Re: Well (L92925, YAMH55206) & UV (Viqua Pro24-186) – [PR #140-2020](#)
Gran Moraine Winery – [PWS # 95573](#)
Final Approval

This verification completes the plan review requirements under PR #101-2018. Final approval is issued at this time, and the facilities included under this review are approved for use (see the following page for a list of approved facilities).

The facilities granted final approval under PR# 140-2020 are as follows:

Viqua Pro24-186 UV units (Part# 660086-R) w/lamp part #602856 (PR#140-2020)

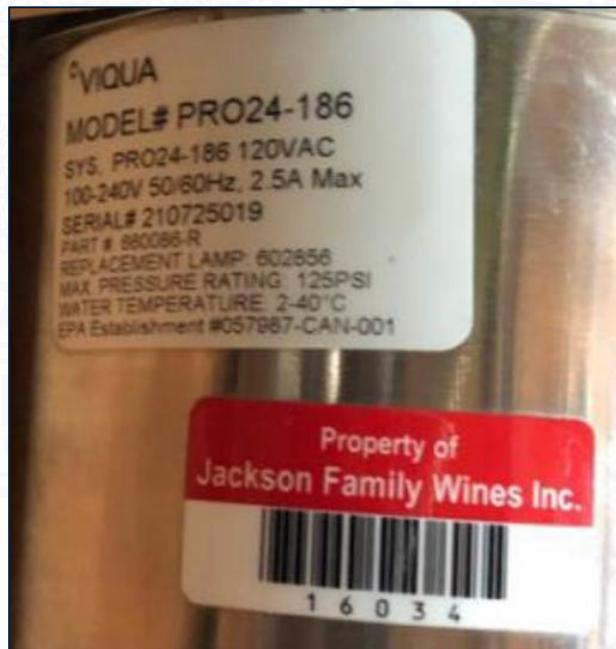
Note: UV light is 186-mJ/cm² thus a chlorine residual for the hauled surface water would not be required at distribution point. It is however required that when the hauled water is delivered that it does have a testable chlorine residual.
